Access Compliance Report

Public Rights-of-Way

(Curb Ramps)

Intersection ID: 13829	Main Street: E_MOREHEAD_ST	Cross Street: DILWORTH_RD	Location:	N
ADA ID: 4F9A88ED586B	Ramp Type: Perp	Initial Pass/Fail: Fail	Overall Compliance: No	Severity Score: 13.75

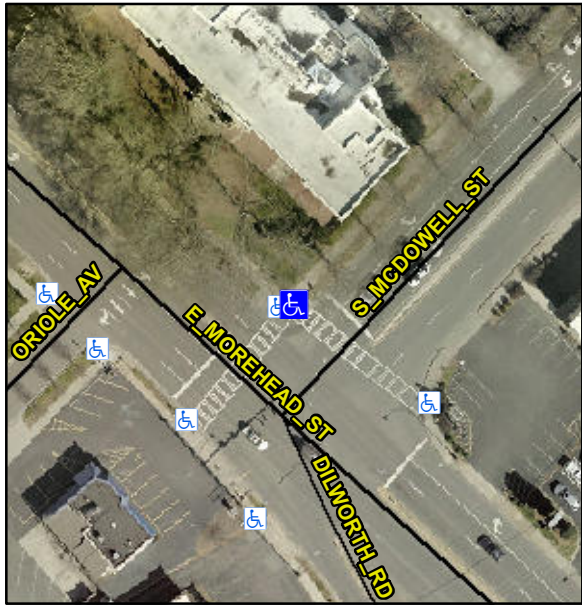
Codes/Mitigation Info/Possible Solution			Field Measurements/Component Compliance					
	Possible Solutions:		Compliance	Description	Data	Compliance	Description	Data
	Remove & Replace Entire Ramp.		N/A	Ramp Length (in)	124.0	No	Ramp Slope (%)	8.5
			Yes	Ramp Width (in)	101.0	Yes	Ramp XSlope (%)	3.5
			N/A	Flare Type LT	N/A	N/A	Flare Type RT	N/A
			N/A	Flare Slope LT (%)	N/A	N/A	Flare Slope RT (%)	N/A
			N/A	Flare Traversable LT?	N/A	N/A	Flare Traversable RT?	N/A
			N/A	Landing Length (in)	N/A	N/A	DWS Provided?	N/A
			N/A	Landing Width (in)	N/A	N/A	DWS Contrast?	N/A
			N/A	Landing Slope (%)	N/A	N/A	DWS Length (in)	N/A
			N/A	Landing X Slope (%)	N/A	N/A	DWS Full Width?	N/A
Surveyor Notes:			N/A	Landing Curb? (Y/N)	N/A	N/A	DWS Offset (in)	N/A
PROW/ADA:			N/A	Shared Landing?	N/A			
Not Found, R304.2.2			N/A	Gutter Ponding?	N/A	N/A	Gutter Slope (%)	N/A
			N/A	Gutter Lip Ht (in)	N/A	N/A	Gutter X Slope (%)	N/A

N/A	Painted X Walk1?	Yes	N/A	Painted X Walk2?	N/A
				X Walk 1 Direction	To SE		X Walk 2 Direction	N/A
			N/A	X Walk 1 Width (in)	108.0	N/A	X Walk 2 Width (in)	N/A
				X Walk 1 Slope (%)	1.9		X Walk 2 Slope (%)	N/A
				X Walk 1 X Slope (%)	4.0		X Walk 2 X Slope (%)	N/A
			N/A	Ramp inside XWalk1?	Yes	N/A	Ramp inside XWalk2?	N/A
				Road Slope (%)	N/A	N/A	Clear Space?	N/A
				Road X Slope (%)	N/A	N/A	Clear Space to XWalk (in)	N/A
			N/A	Any Obstructions?	N/A	N/A	Storm Grate/Utility Hazard?	N/A
				Obstruction Type			Storm Grate/Utility Type	
					N/A			N/A
						Yes	Surface Condition? (G/P)	Good
Total Cost:		\$ 1850.00
